RE: Frank Residence, 8349 Reservoir Rd. Fulton, MD

Waiver Approval

8349 Reservoir Road Fulton, MD 20759

This letter constitutes a request for a variance as outlined below, for the House owned by Steve and Robyn Frank at 8349 Reservoir Road, Fulton, MD 20759

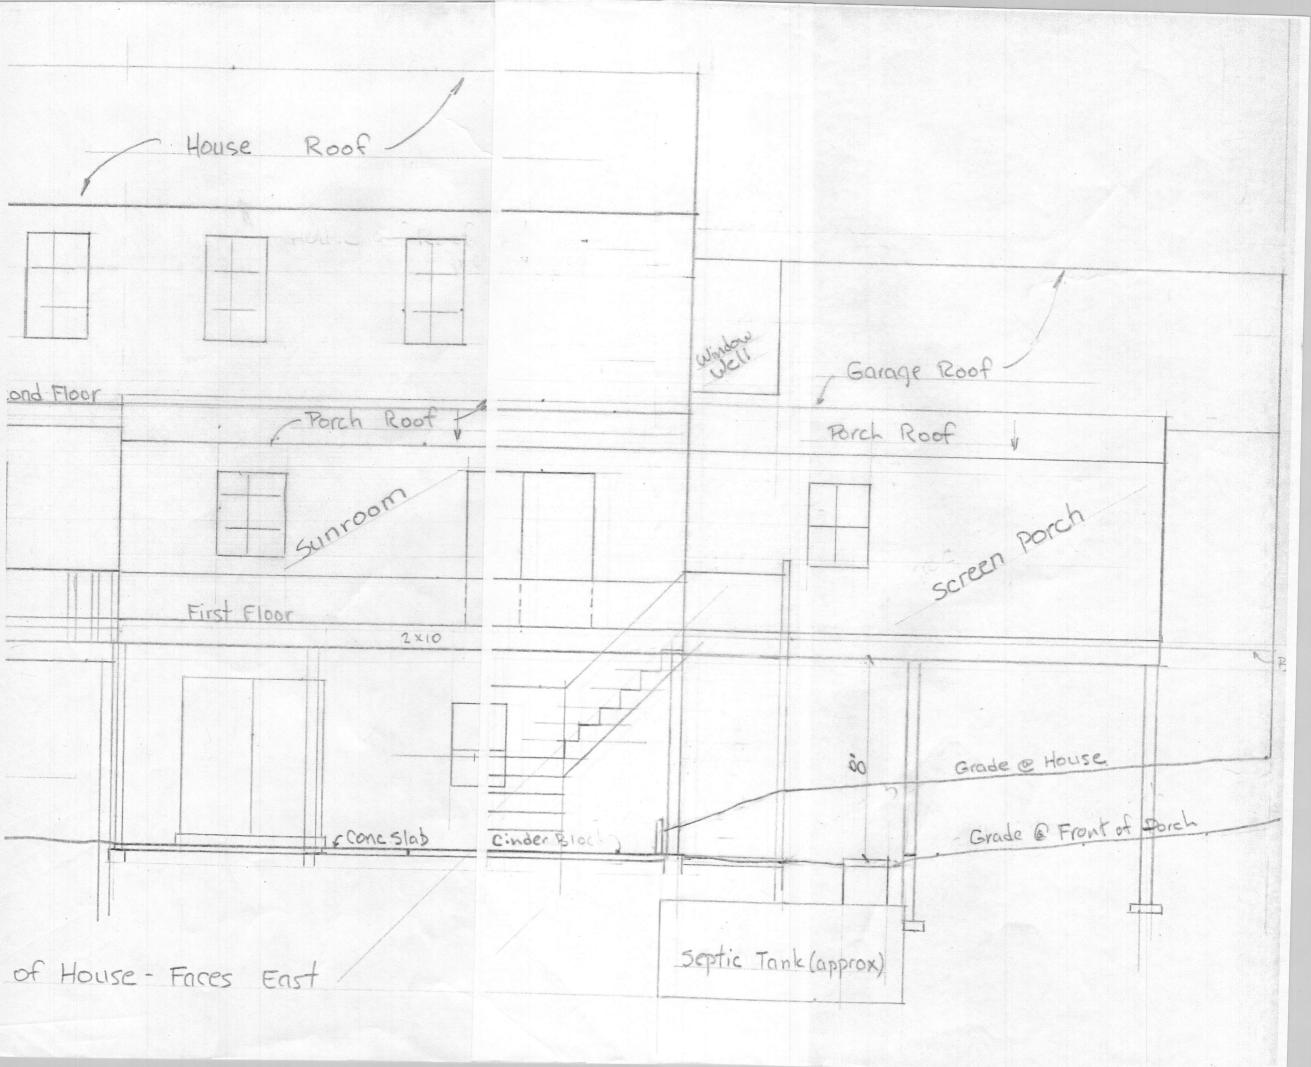
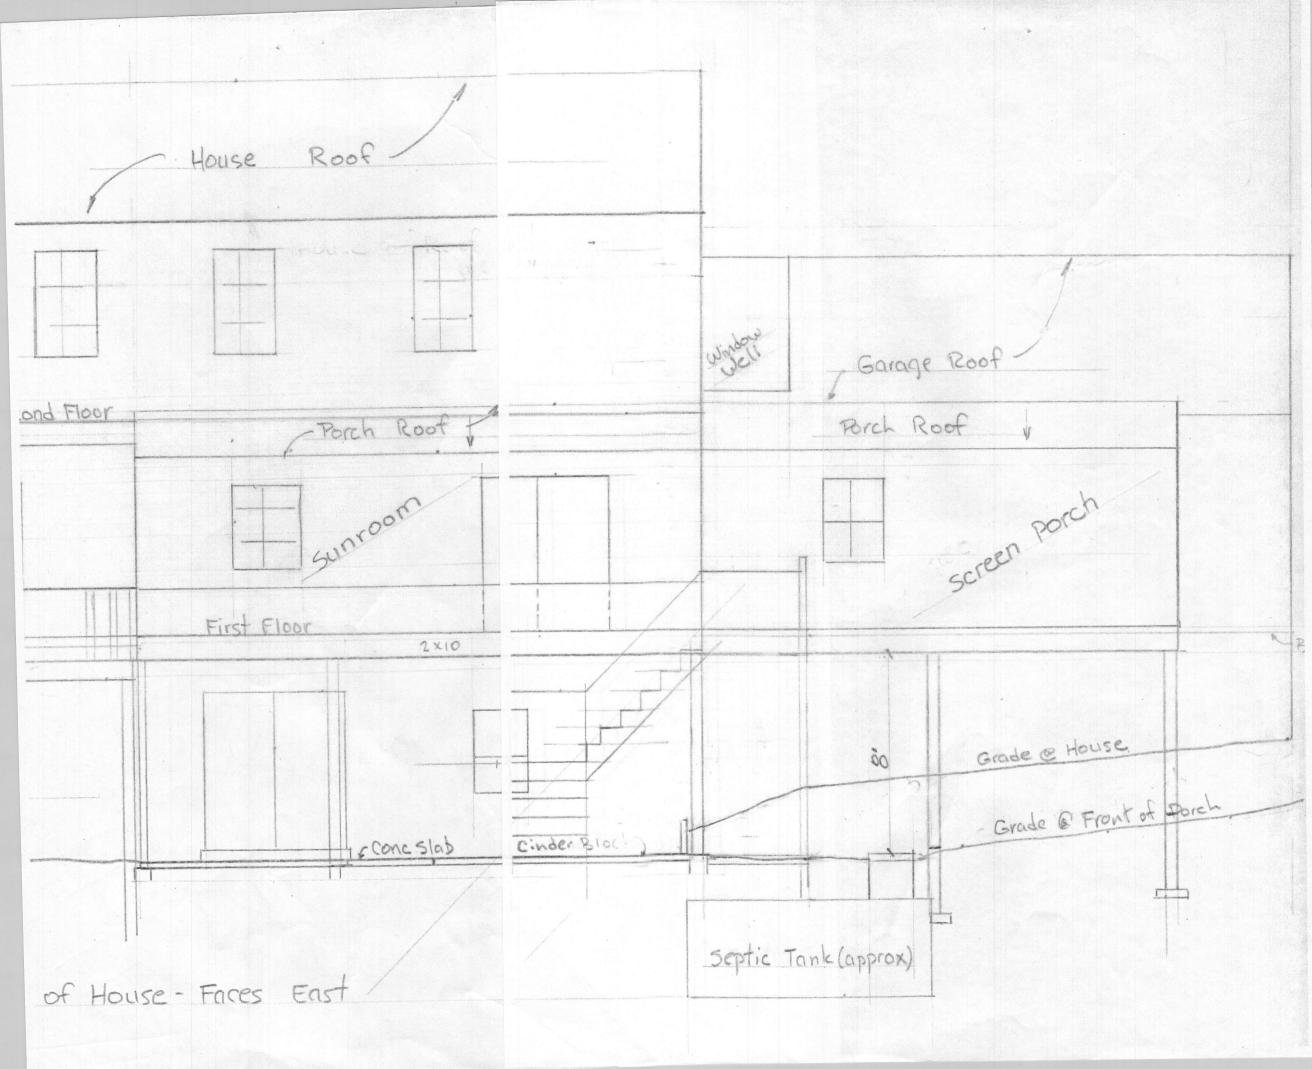
The Howard county septic regulations prescribe a five foot offset from footings to a septic tank. We are asking for a variance to be allowed to come within 2 or 3 three feet of the existing septic tank with one or two pier footings. These are not continuous wall footings, they are point load footings with no construction of habitable space directly above the septic tank. We are in fact removing part of an enclosed sunroom that currently encroaches over the tank.

Allowing the variance would significantly simplify the framing for the flooring of the addition above; in one location we are violating the 3 to 1 cantilever rule for the floor framing if we are required to stay 5 feet distant with our pier footings.

I include the schematic drawings which include two schematic floor framing plans that also show the footings—the plan we would hope to use shows one footing coming within 2 feet of the tank.

The Health Department received your waiver request dated January 15, 2014 for the above referenced property. This agency will grant approval of the waiver to the required setback for the deck footings to the existing septic tank. The approval is based on your statement that the footing will extend to the bottom of the septic tank to avoid any lateral pressure on the tank. The construction drawings will need to be revised with DILP so they be aware of the extended footing depth. Any deviations from the site plan submitted with the request will be subject to further review by this Department.
